STATE OF NORTH CAROLINA
DEPARTMENT OF TRANSPORTATION

Subject: Revised Application for Individual Section 404 and 401 Permits and Neuse Riparian Buffer Authorization for the construction of the southern section of Crescent Road from US 70 to US 258 in Lenoir County, west of Kinston. State Project No. 8.2200101. Federal Aid Project Number STP-224(3). TIP No. R-2719A., WBS 34501.1.1.

The purpose of this letter is to provide a revision to the application for a Section 404 Individual Permit, Section 401 Water Quality Certification, and Neuse Riparian Buffer Authorization. In addition to the cover letter this application package includes the following: revised permit drawings, a set of revised half size roadway plans, and a revised mitigation plan.

PLAN VIEW SITES 8 CONT', 9 & 10

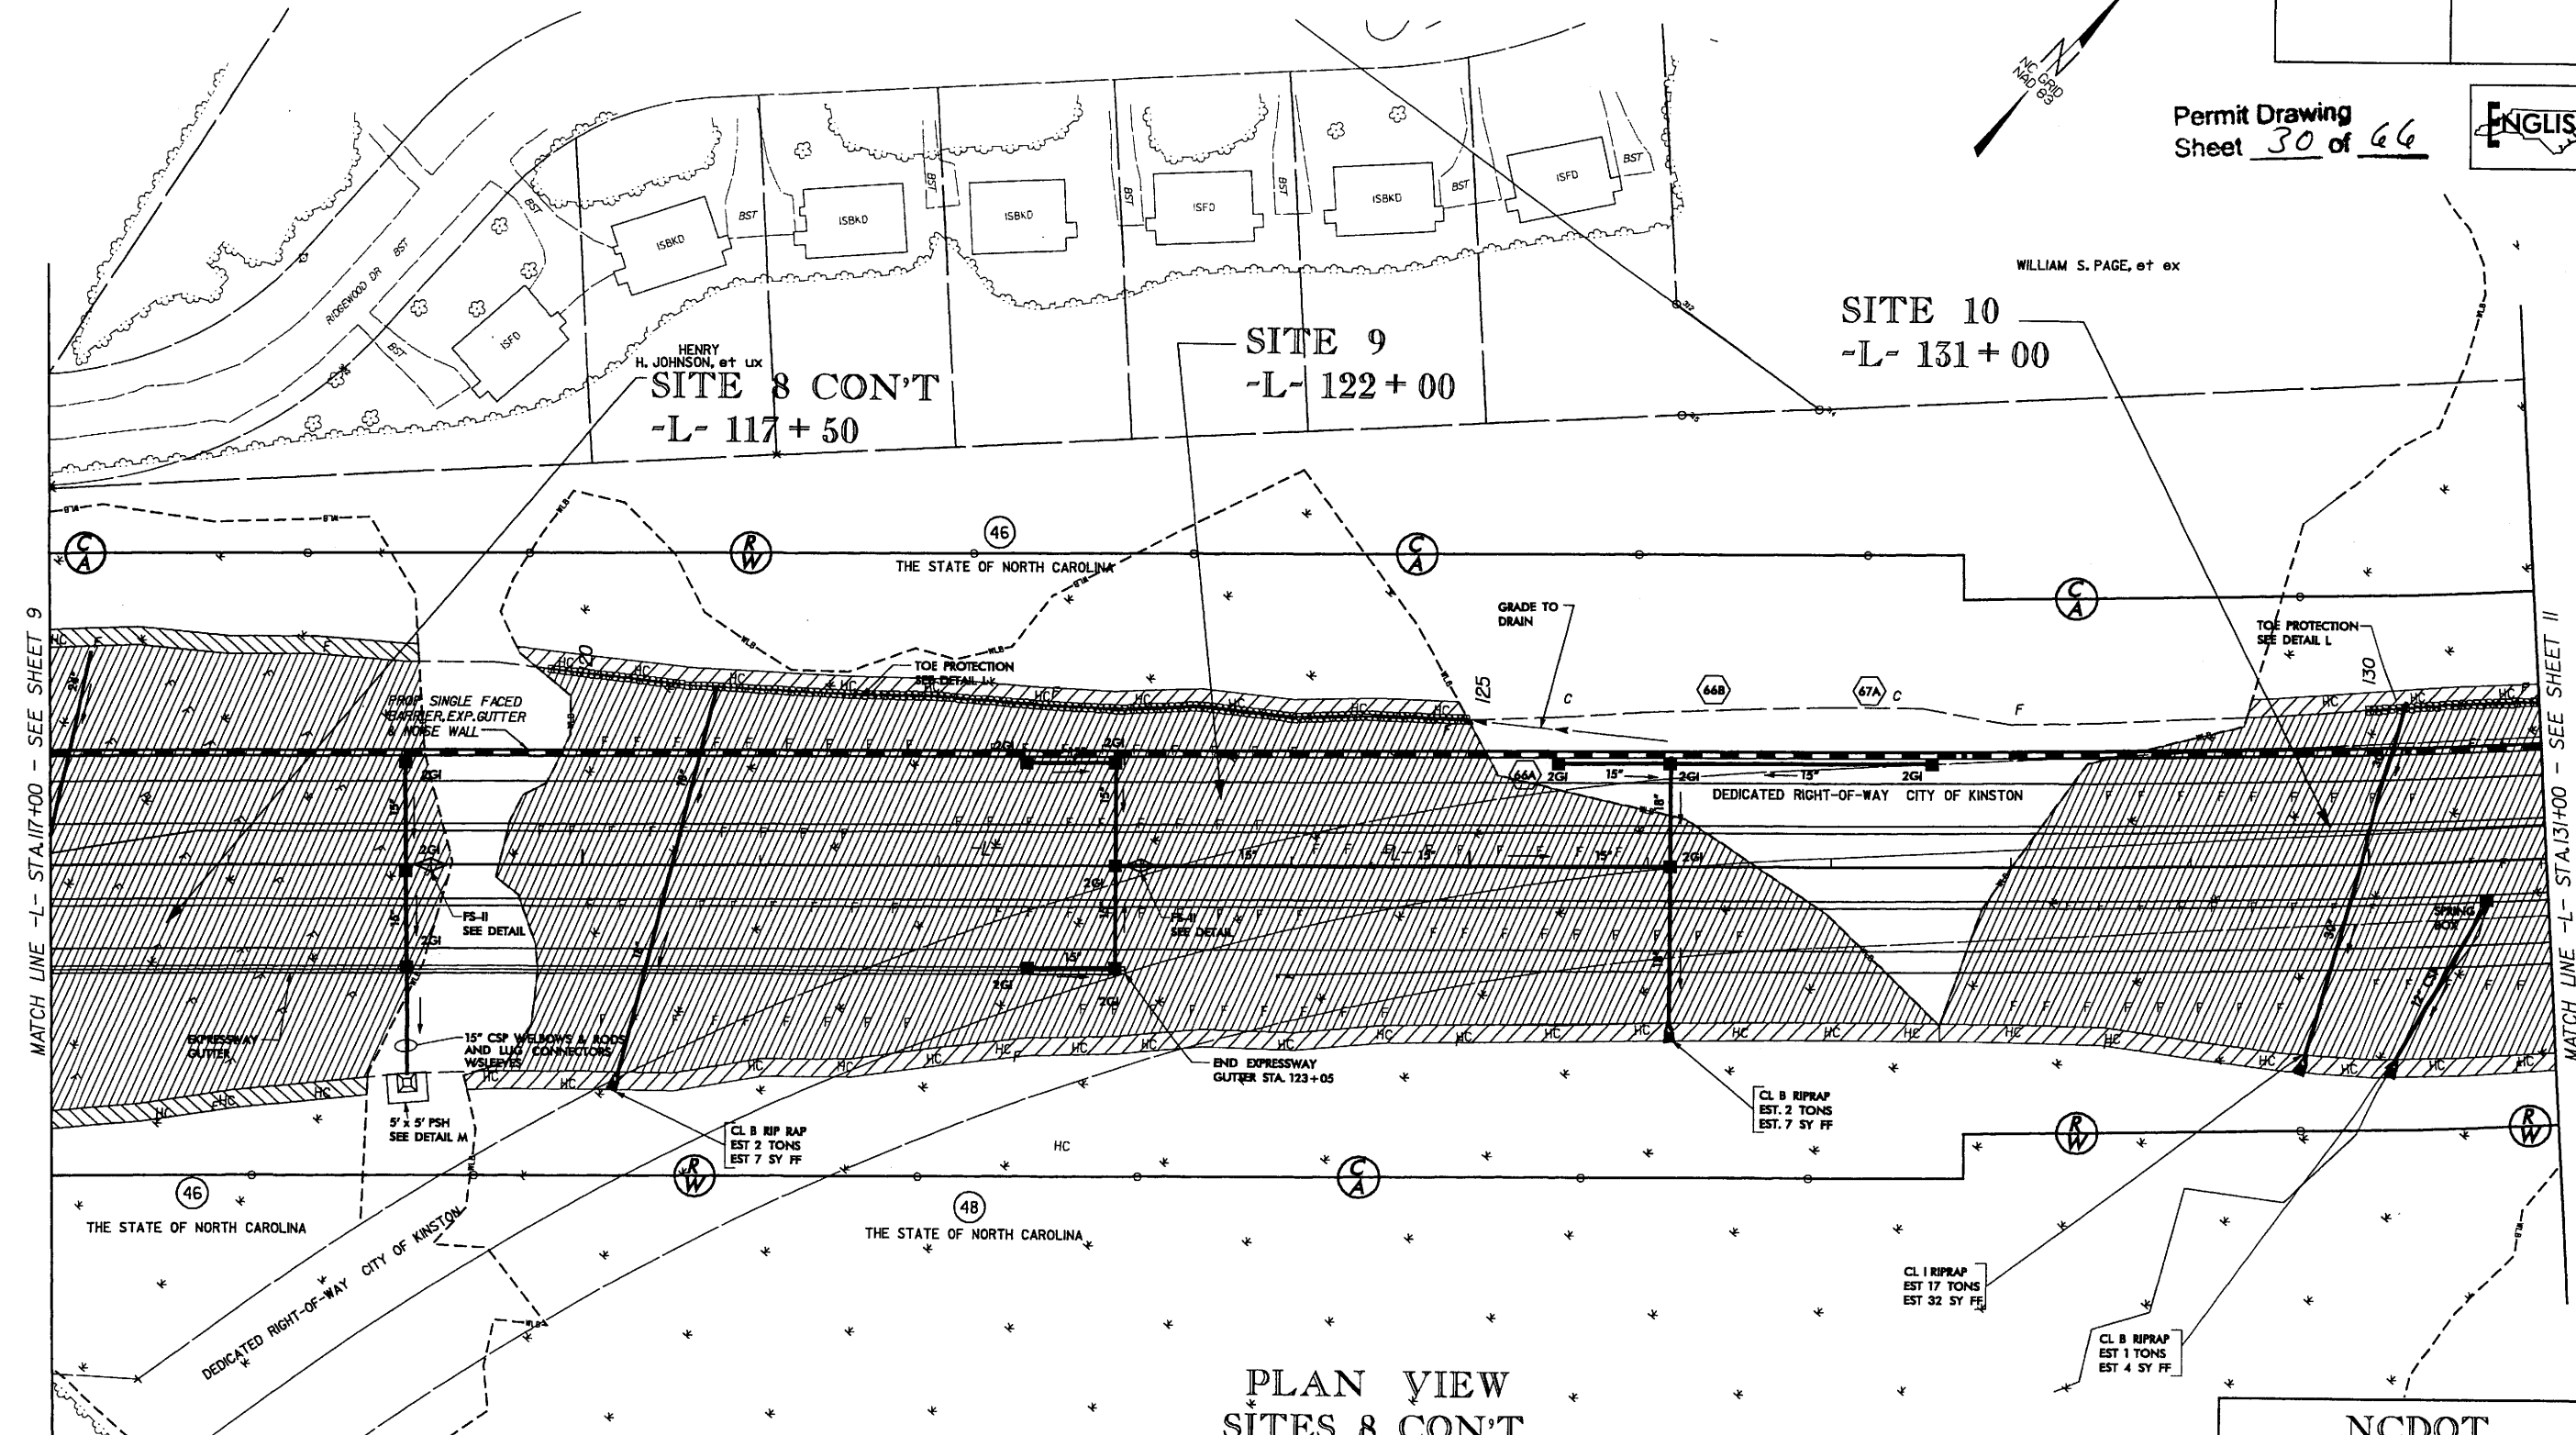
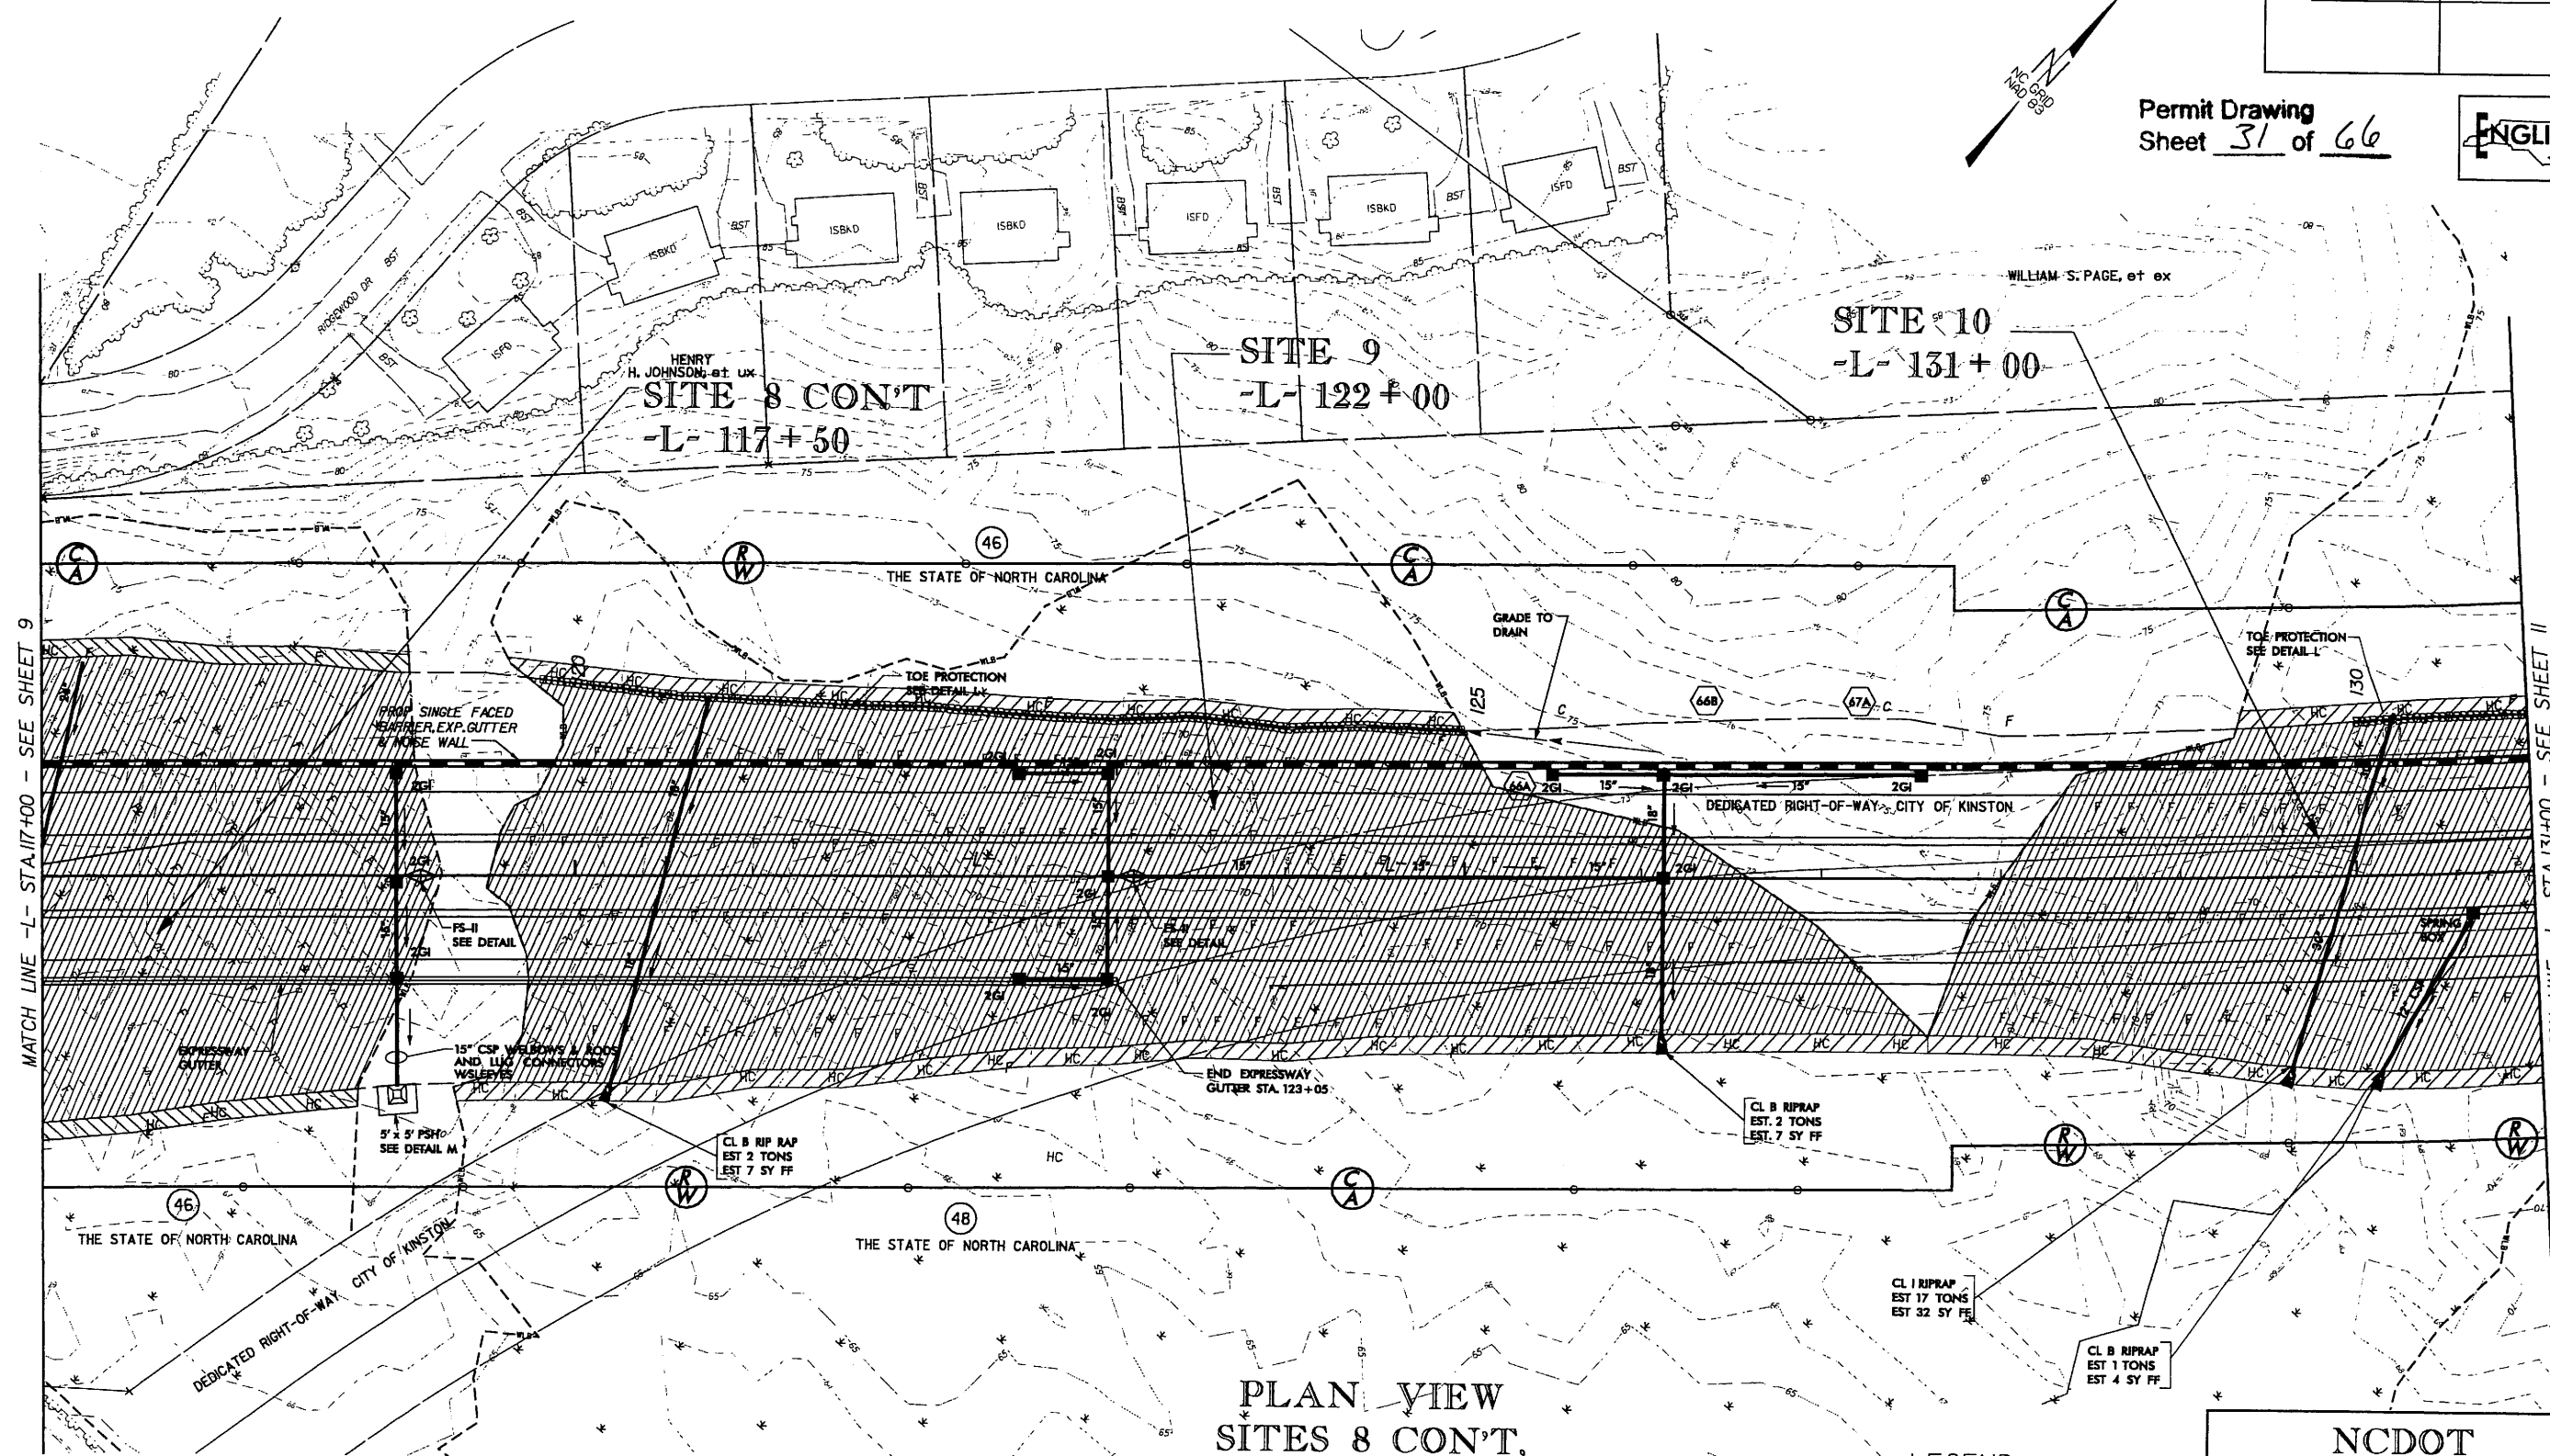
This revision describes the changes in the wetlands impacts due to the outcome of the reverification of the wetlands; also to describe the design change at the railroad crossing. NCDOT redelineated wetlands, due to the expiration of the jurisdictional determination. Several of the wetland lines were shifted as a result of this redelineation. Permit sites 8, 9, 10, 14, and 16 were changed and were verified by William Wescott with the USACE on March 6, 2008.
